**Proposed Rezoning of the Site from “Other Specified Uses” annotated “Business” to “Other Specified Uses” annotated “Residential Care Home for the Elderly and Hotel”
for a Proposed Composite Development with RCHE and Hotel
at Nos. 107 – 109 Wai Yip Street, Kwun Tong
(Planning Application No. Y/K14S/4)**

Response-to-Comment Table

(Planning Application No. Y/K14S/4)

SECTION A SK-14 21 JANUARY 2025

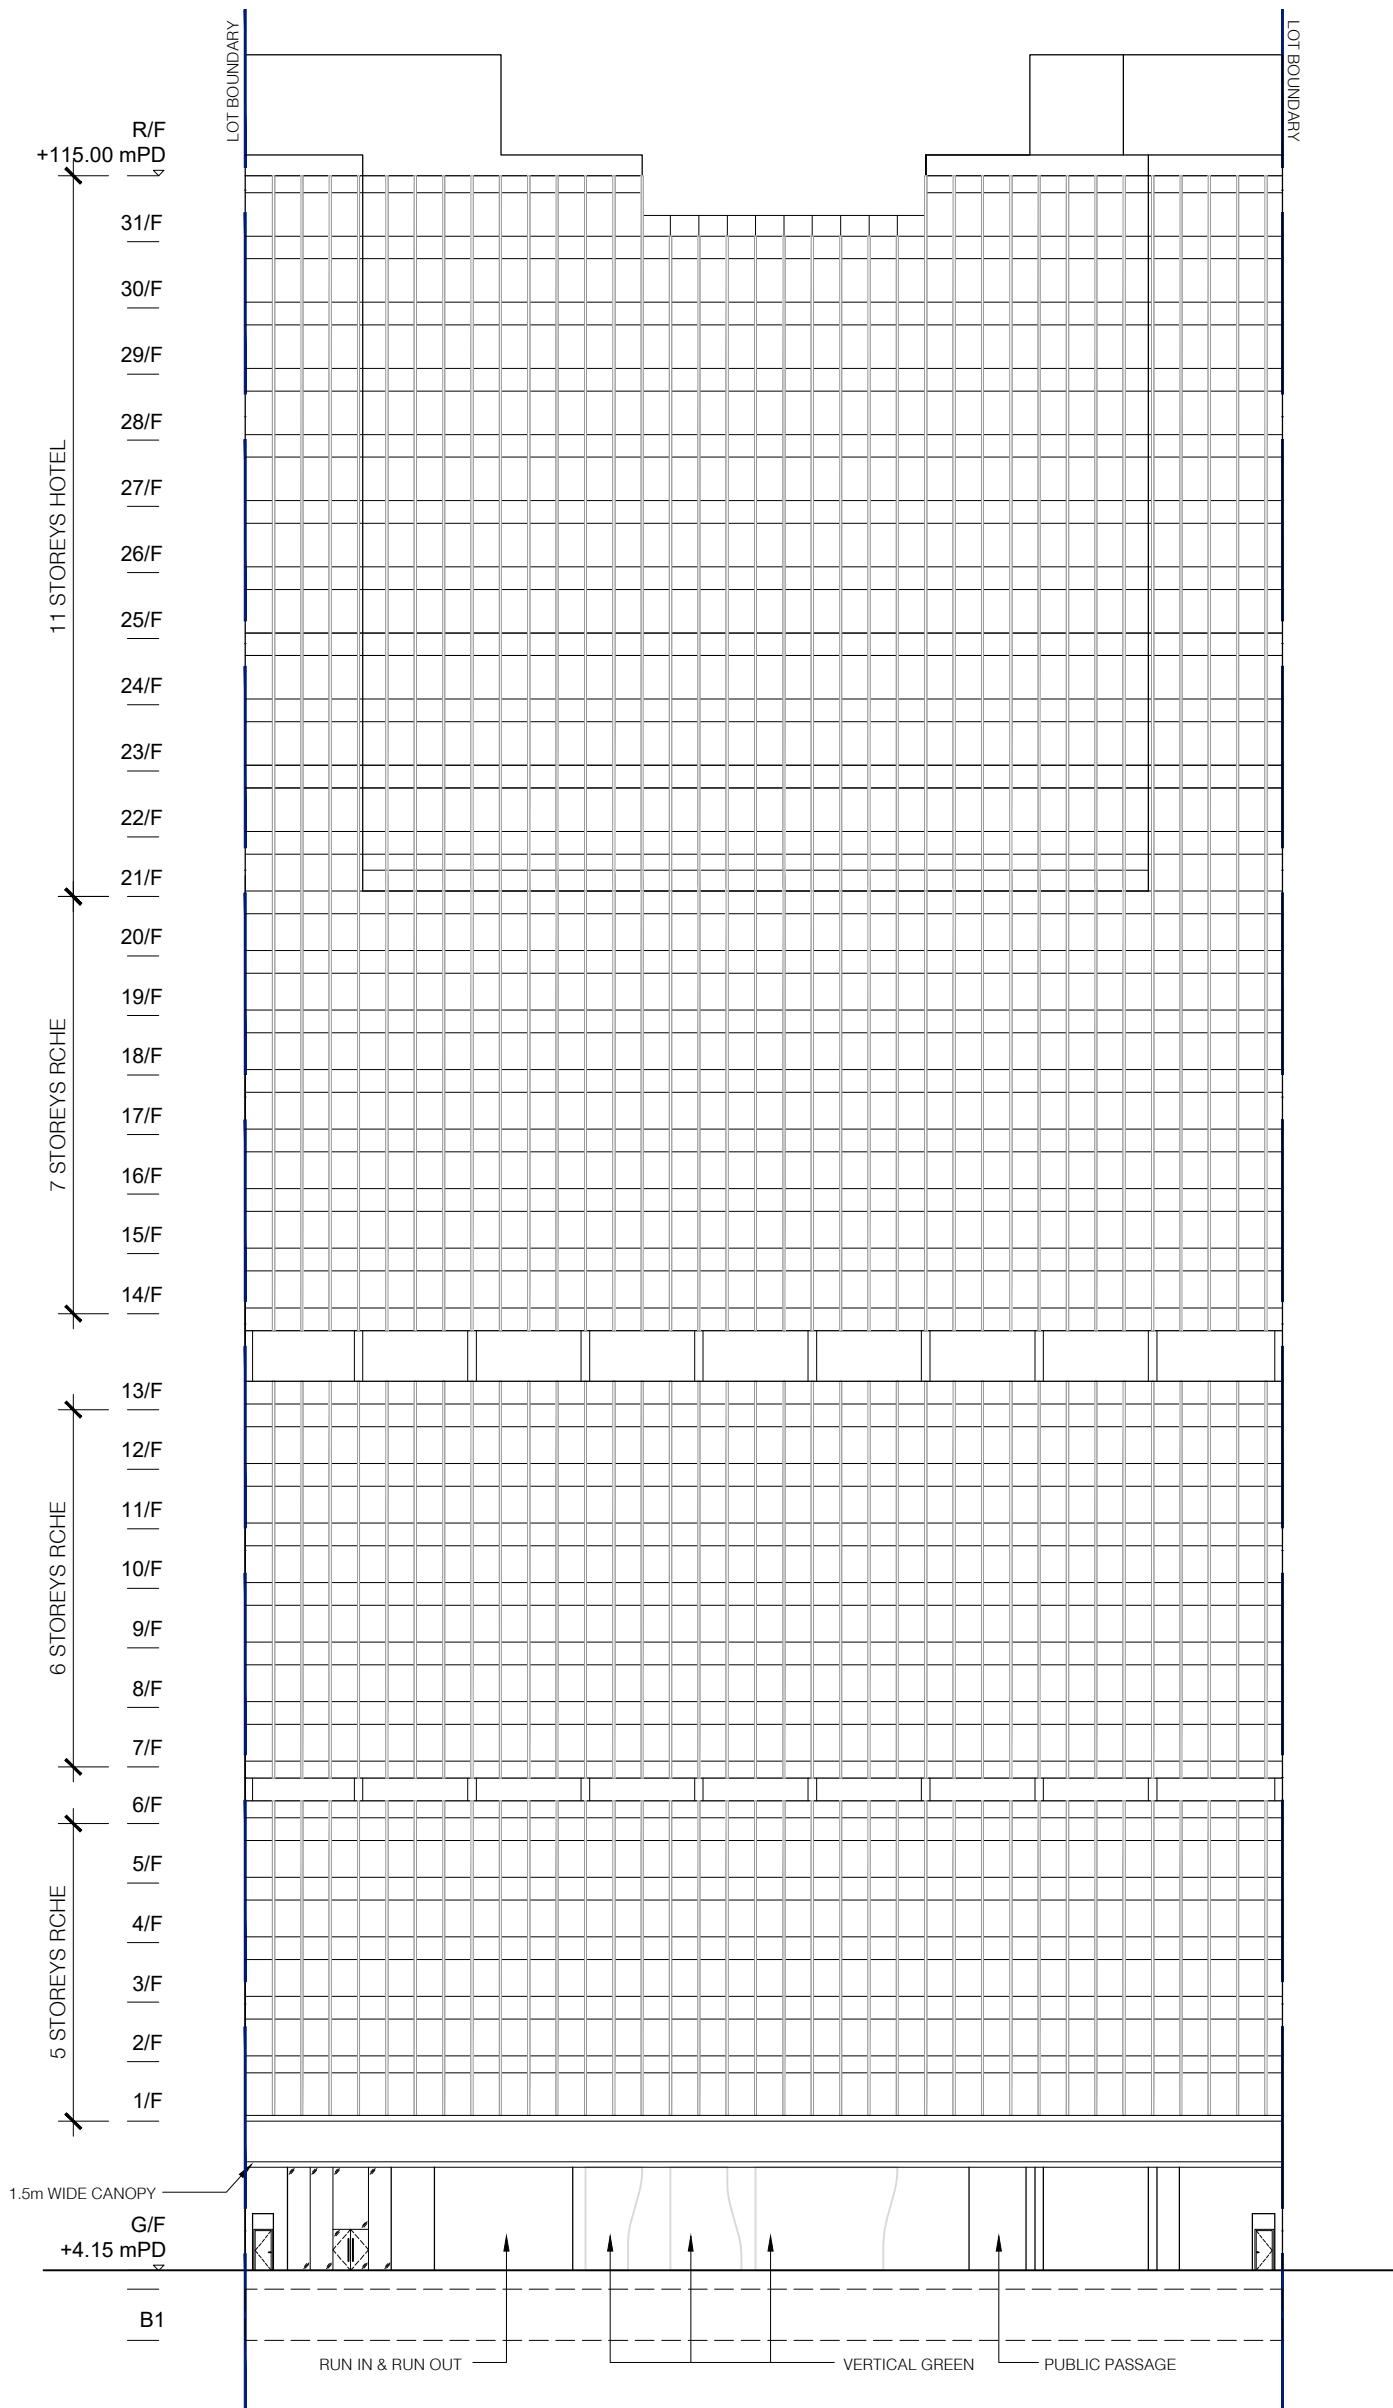
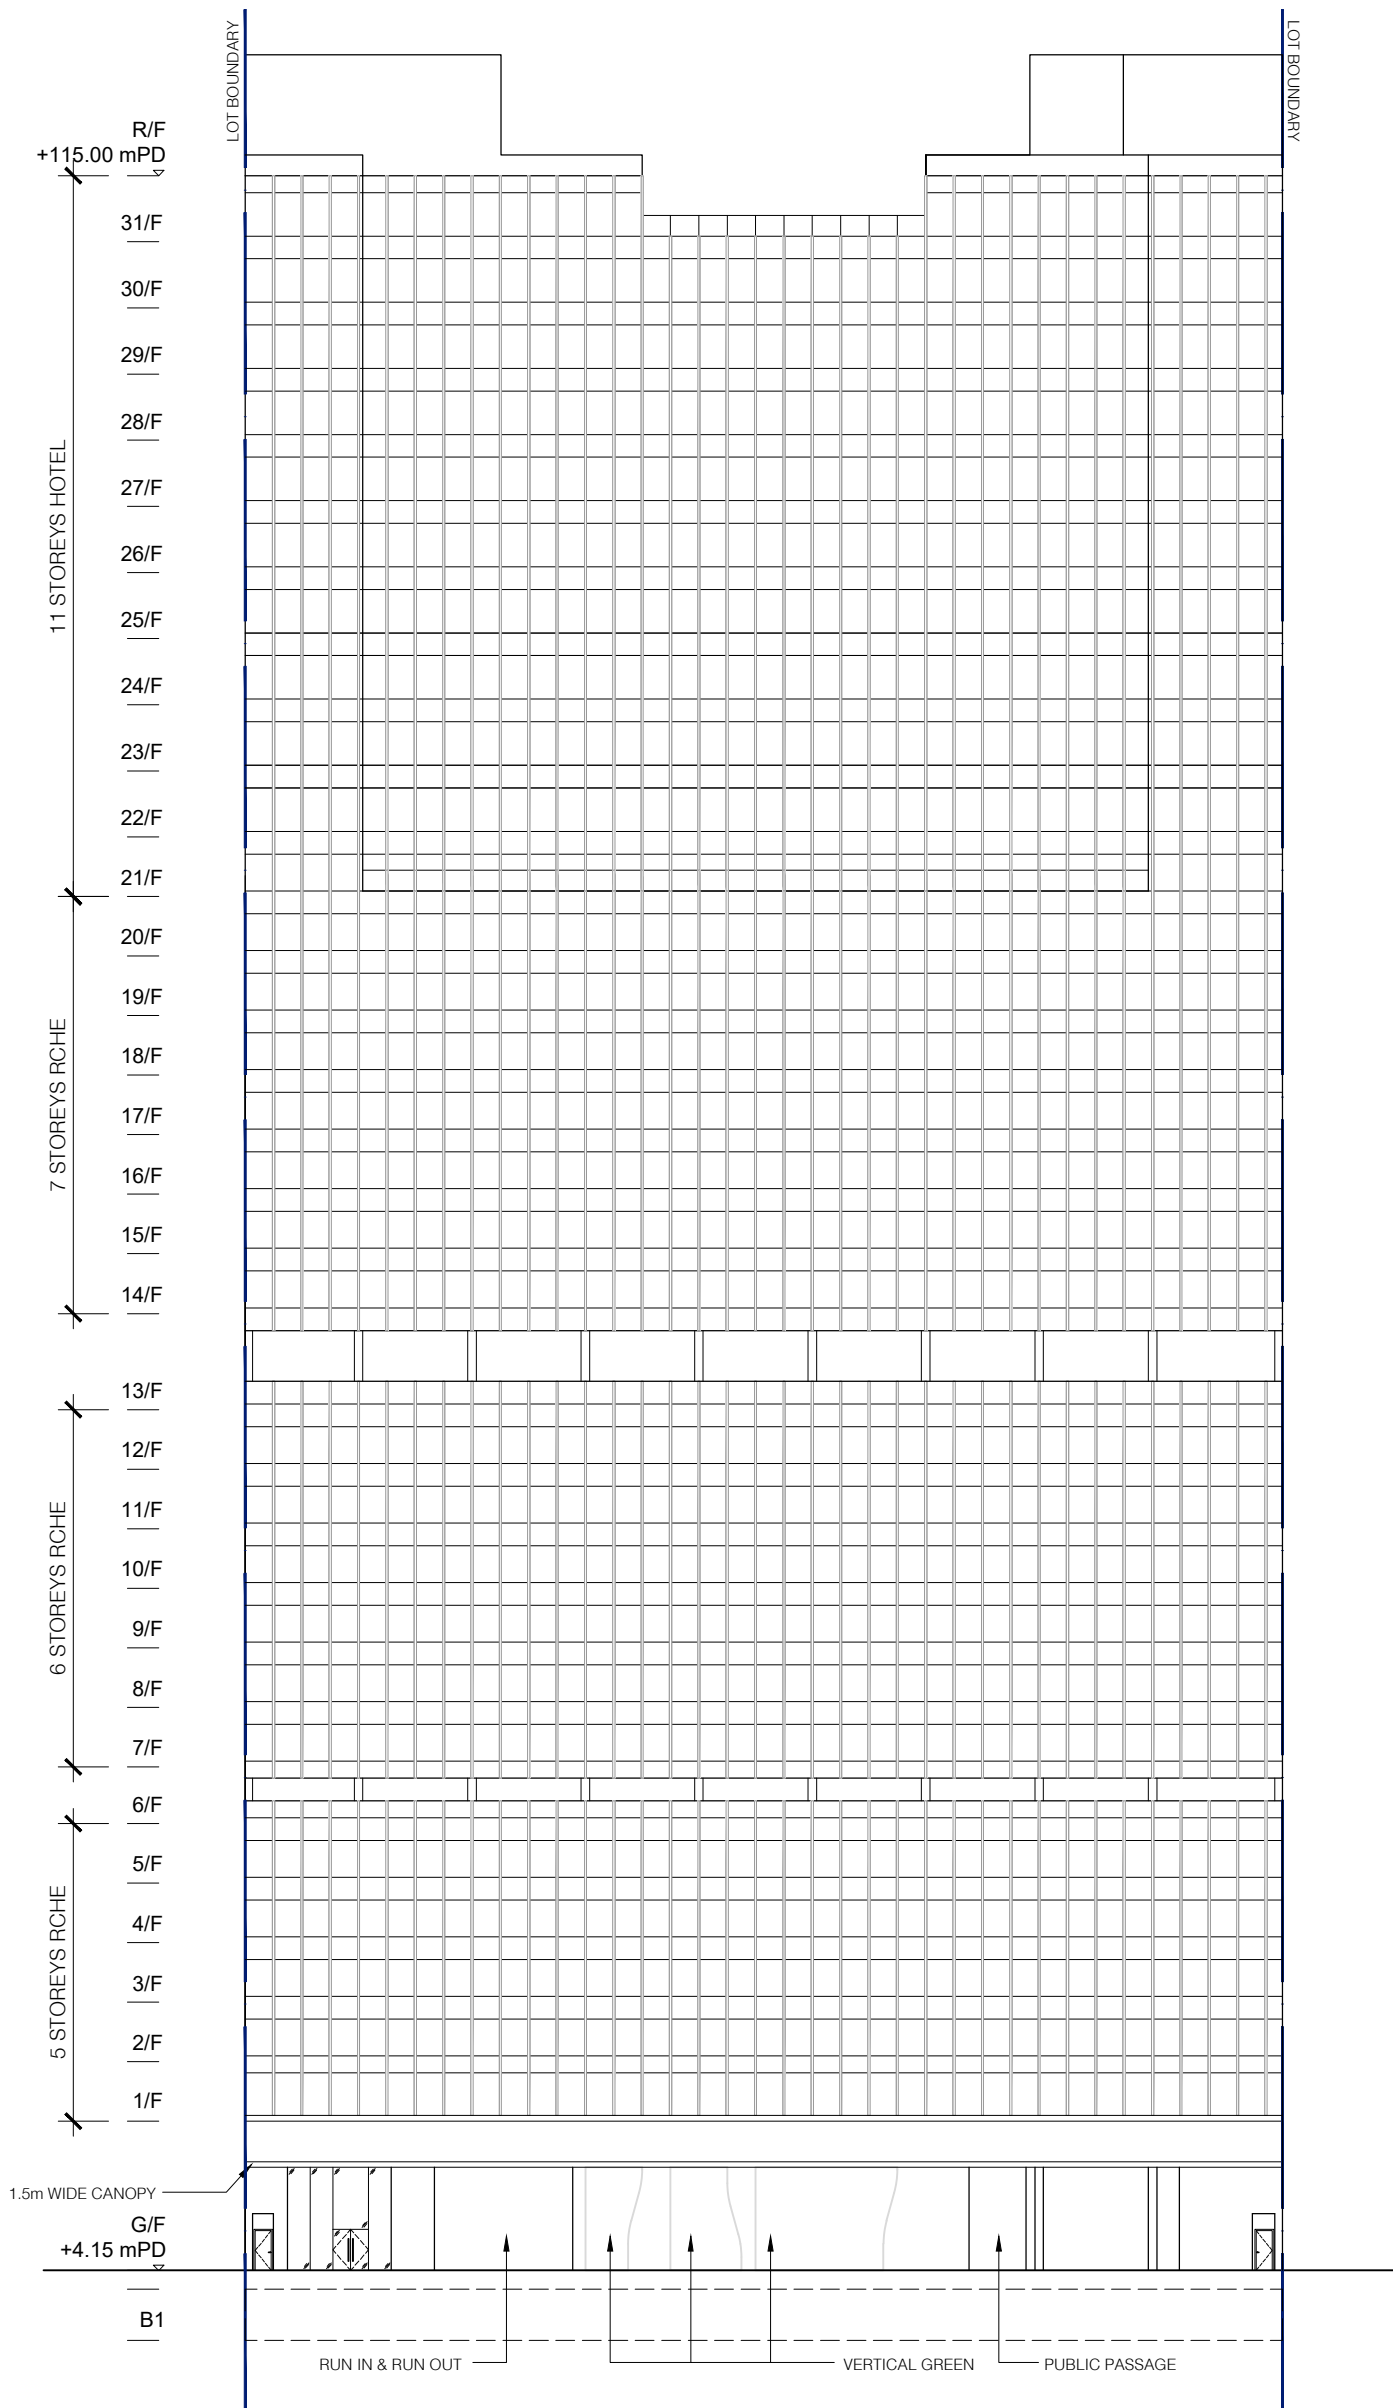
| Comments | Summary & Response/Action |
|--|---|
| <p>17. Section Plan Drawing No. SK-14- please annotate the maximum BH for the RCHE portion.</p> <p>18. Bulletpoint 3 in Para. 3.4.1 of the SPS: As stated in the SPS, the landscape areas on 3/F and R/F are accessible to building users 24 hours a day. Please clarify whether all users are permitted to use both landscaped areas, particularly whether elderly residents in the lower portion of the composite building would have access to the landscaped area on R/F (which is logically a part of the hotel portion).</p> | <p>Please refer to the revised drawing no. SK-14 (Appendix II refers).</p> <p>Subject to later detail design stage, please note that 3/F podium roof is intended to serve RCHE and R/F green roof is intended to serve the hotel during operating hours only.</p> |

Figure 2.1

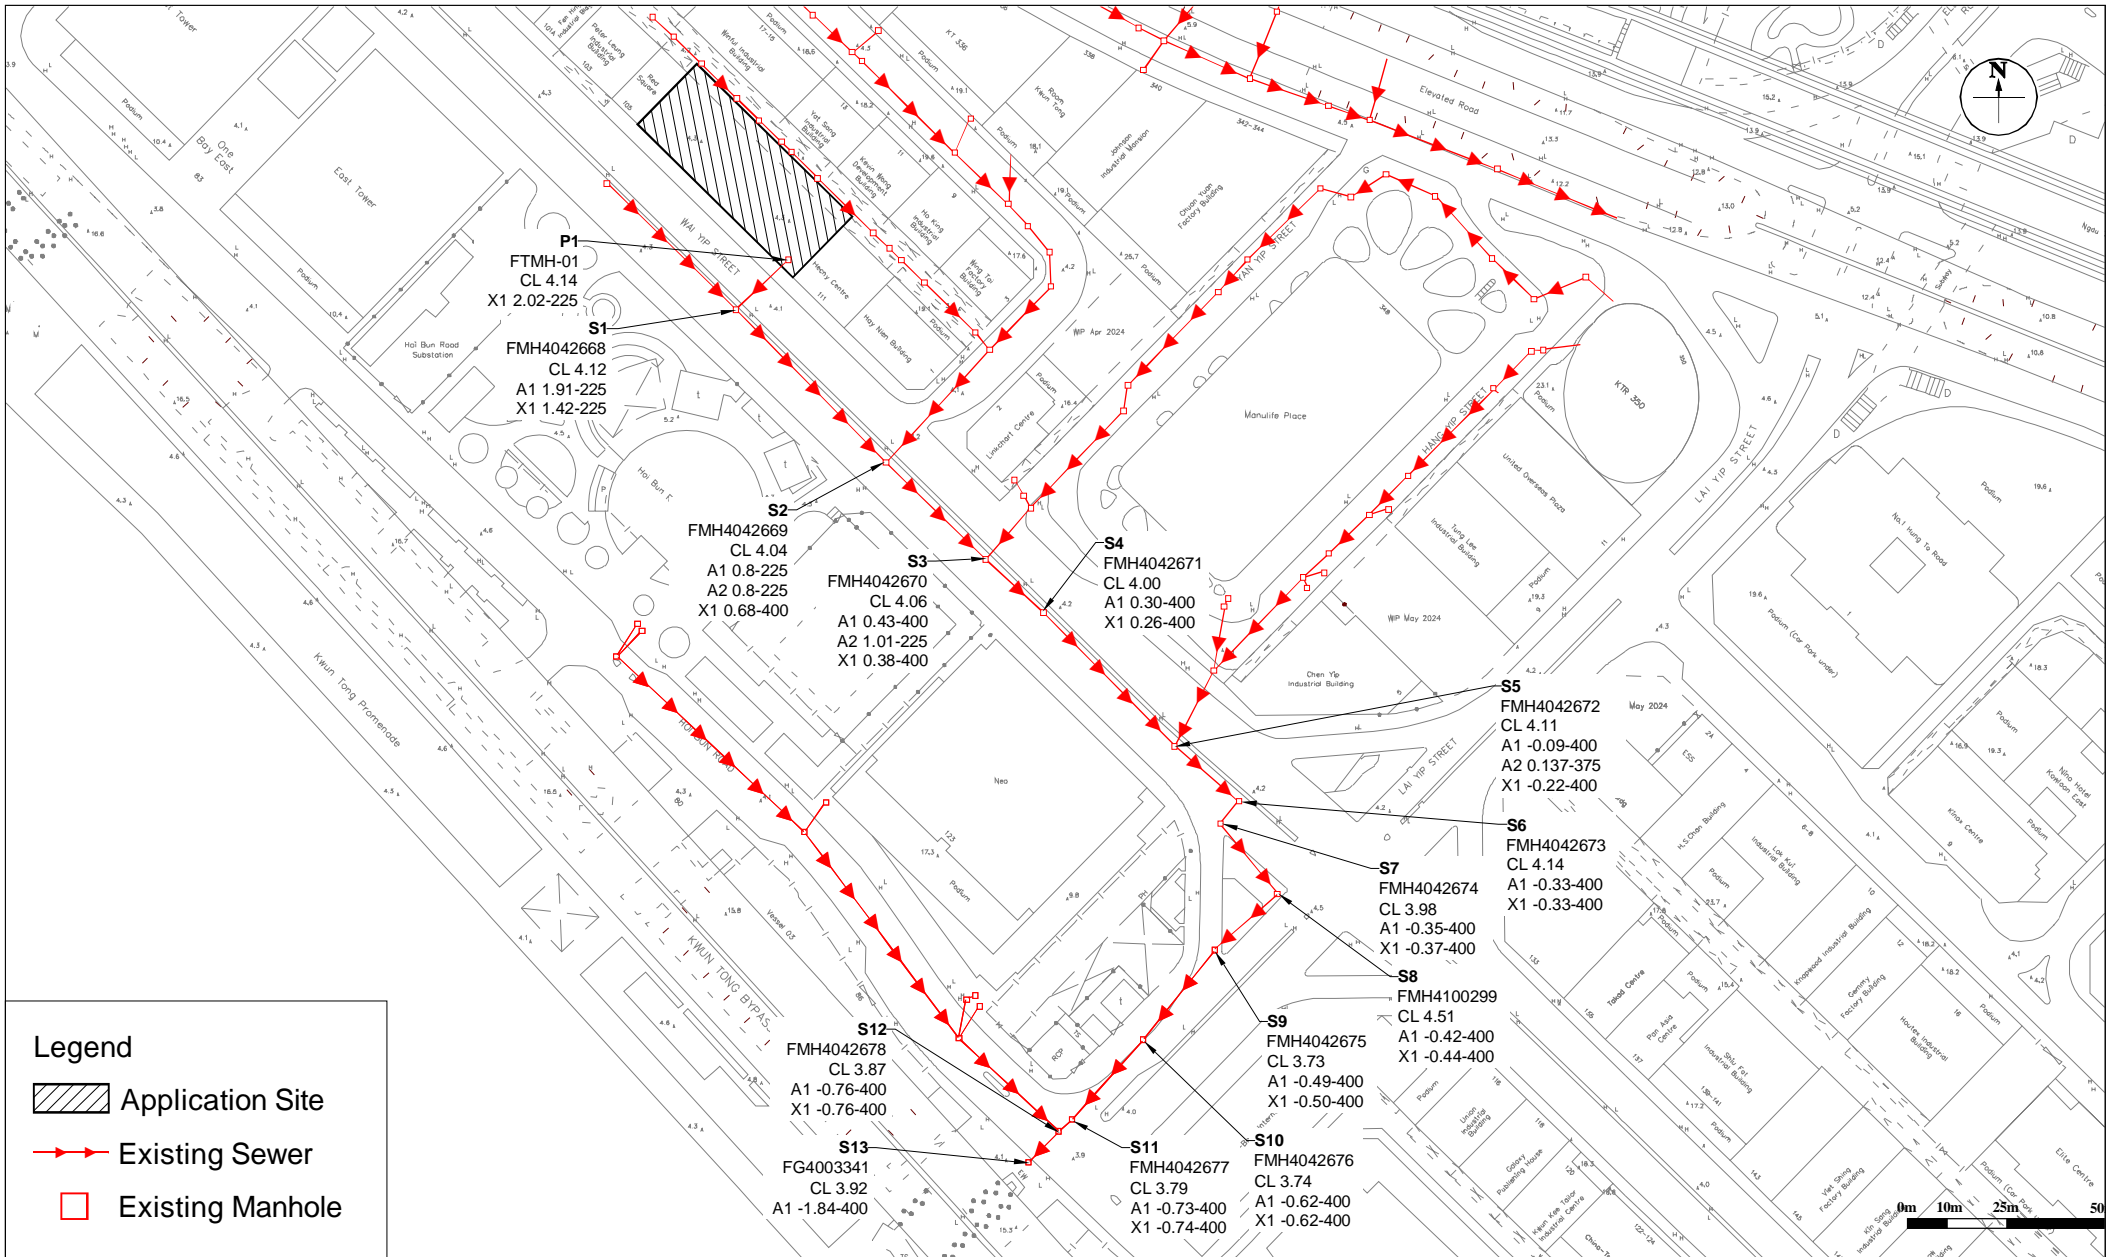
| Comments | Summary & Response/Action |
|--|--|
| <ul style="list-style-type: none"> • For any pipes (including existing connection pipes from the lot) proposed to be abandoned / modified / constructed, please present with proper legends/colors to distinguish for clarity. | <p>The Site has been cleared and is currently vacant. No sewers are required to be abandoned or modified. The indicative location of the new terminal sewer manhole (P1) is shown in Figure 2.1.</p> |
| <ul style="list-style-type: none"> • Please indicate pipe sizes and manhole details (ref nos., invert levels, etc.) in the layout. | <p>The required information has been indicated in Figure 2.1.</p> |
